## IBR's "Tunnel Concept Assessment" is misleading

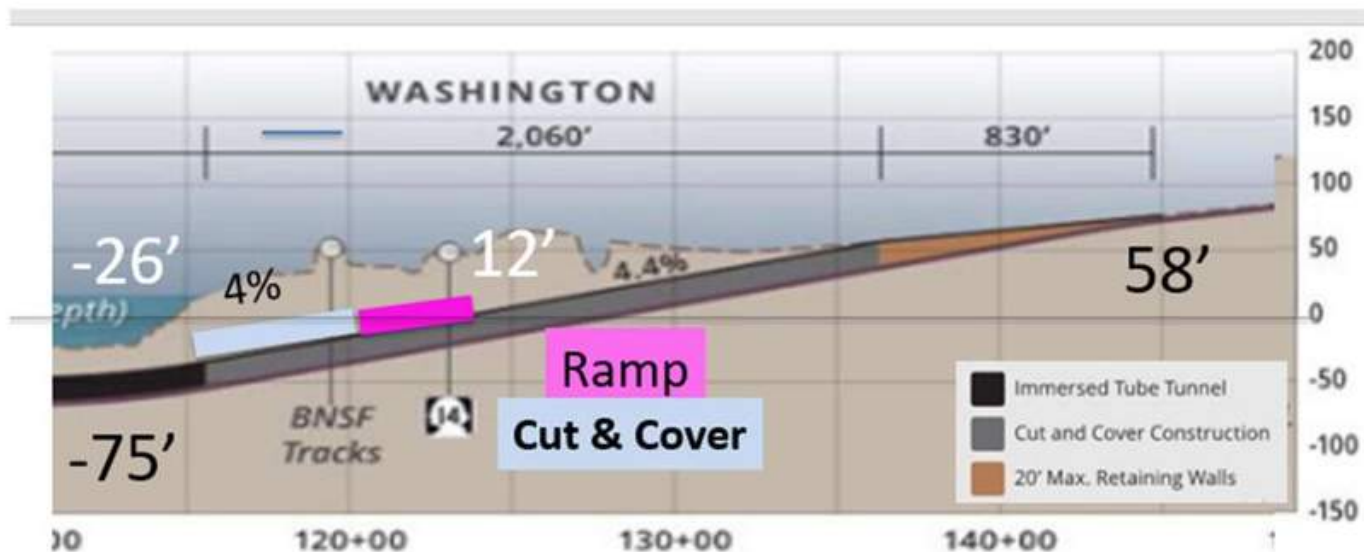
The Interstate Bridge Replacement Program's "Tunnel Concept Assessment" is incorrect and misleading because it evaluated a tunnel that goes under three current barge channels that would not exist with an immersed tunnel.

The IBR's "Tunnel Concept Assessment" requires a long steep ramp and cut & cover section to get under the primary channel at the current bridge lift. This channel will not be needed with an immersed tunnel. An immersed tunnel can have a ramp and cut & cover section one third as long and with 90% less excavation and cost.

The IBR graphic has a very poor scale and does not have an accurate elevation profile.

Distances and elevations can be checked with Google Earth.

Table 1. Preliminary Tunnel Excavation Quantities Upstream Alignment

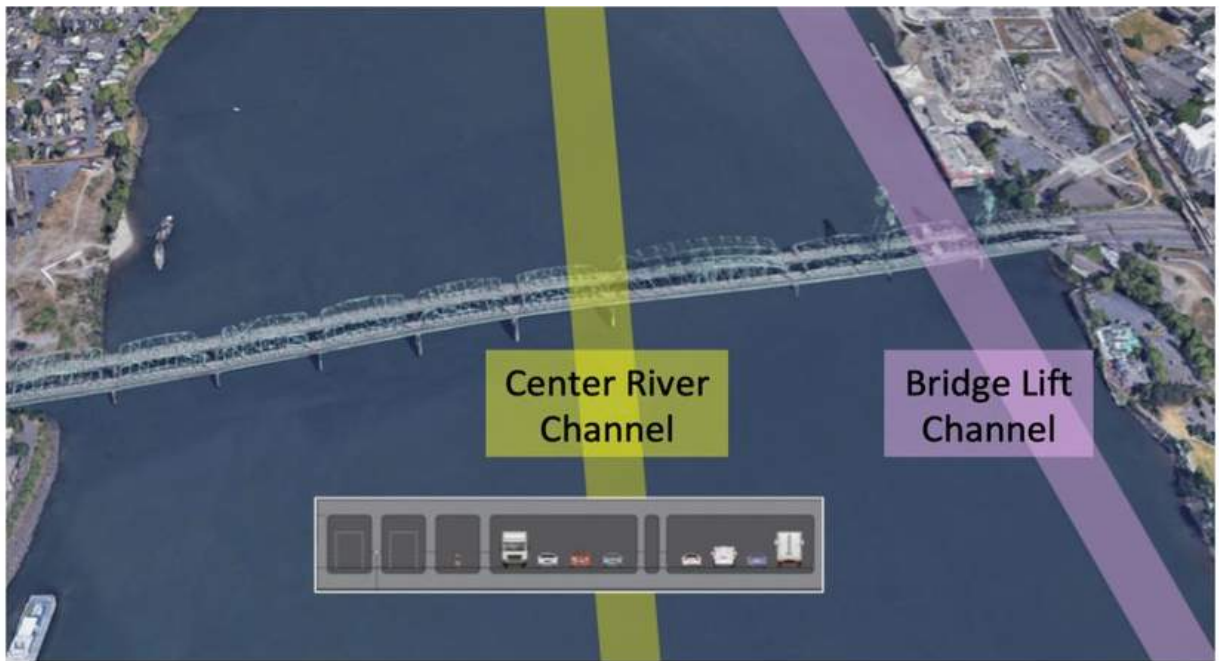
The IBR's misleading evaluation has extremely inaccurate estimates of excavation, 7.9 million cubic yards.

Location	Bridge Lift Channel	Center River Channel
Hayden Island (on land)	1,800,000 yd <sup>3</sup>	169,000 yd <sup>3</sup>
Columbia River (in water)	3,800,000 yd <sup>3</sup>	1,223,000 yd <sup>3</sup>
Vancouver (on land)	2,300,000 yd <sup>3</sup>	138,000 yd <sup>3</sup>
<b>Total</b>	<b>100% 7,900,000 yd<sup>3</sup></b>	<b>19% 1,530,000 yd<sup>3</sup></b>
